**Re: S216-011 MANATEE ISLES PLAT  
RESPONSE TO STAFF REPORT FINAL COMMENTS**

Our office is in receipt of comments received on July 19, 2018 in regards to the Manatee Isles Plat application. This letter represents our response to the comments received regarding the Development Review Staff Report. Each comment is identified below followed by a response in **bold italics**.

**RE: Manatee Isles – Plat application S216-011  
Engineer's Certification – Public Flow-Through Drainage Easement**

BOUNDARY SURVEY  
FOR: MANATEE ISLES  
PORTION OF BLOCK 11  
SALERNO SHORES  
PLAT BOOK 11, PAGE 33, PALM BEACH  
MARTIN COUNTY, FLORIDA

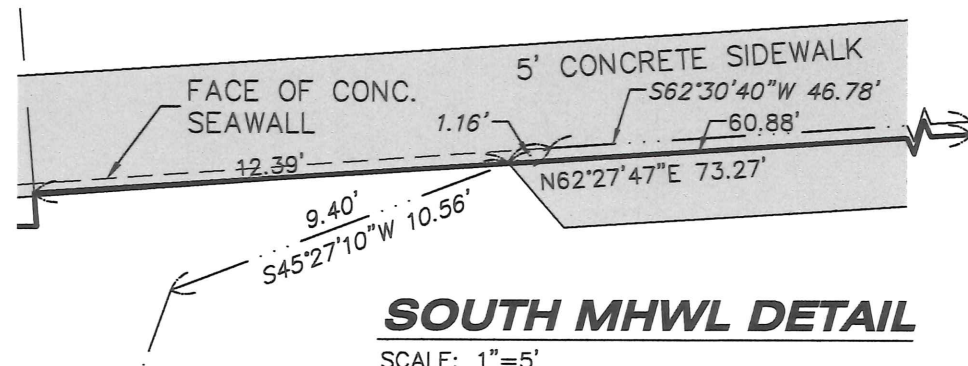
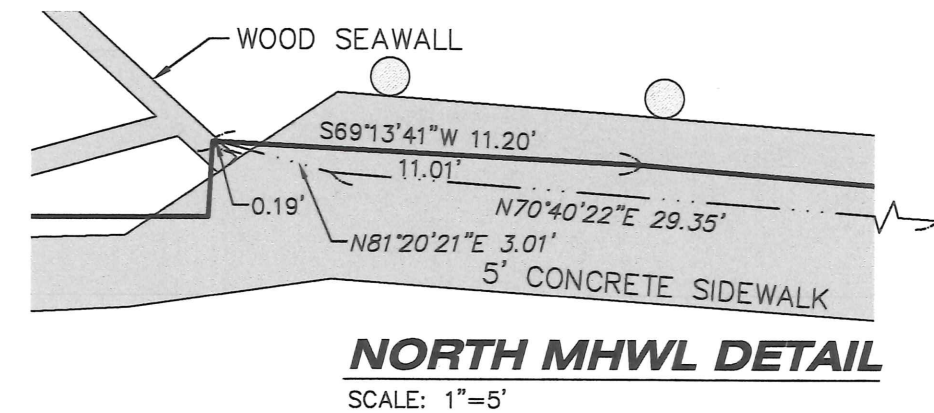
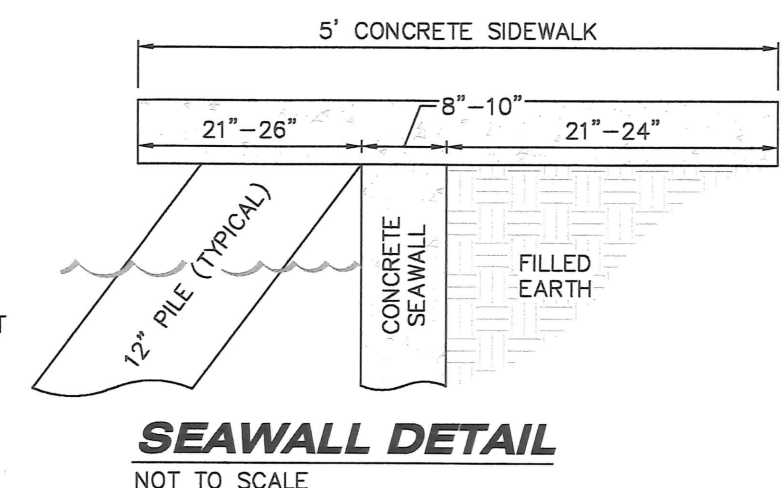
Provided Boundary Survey is not certified and does not include a title opinion of an attorney or certification by an abstractor. Boundary Survey also does not show the Point of Commencement or Point of Beginning. Insure Survey meets all Standards of Practice.

Address Mean High Water Line requirement of the plat.

**RESPONSE:** *Please see the revised boundary survey which includes certifications and title opinion of an attorney. The points of commencement and beginning are also depicted on the revised boundary survey.*

**RESPONSE:** *The mean high waterline follows the seawall, which meanders in and out of the described property limits at courses very similar to the recorded legal description. The described property line will be monumented. See attached boundary survey for mean high waterline location.*
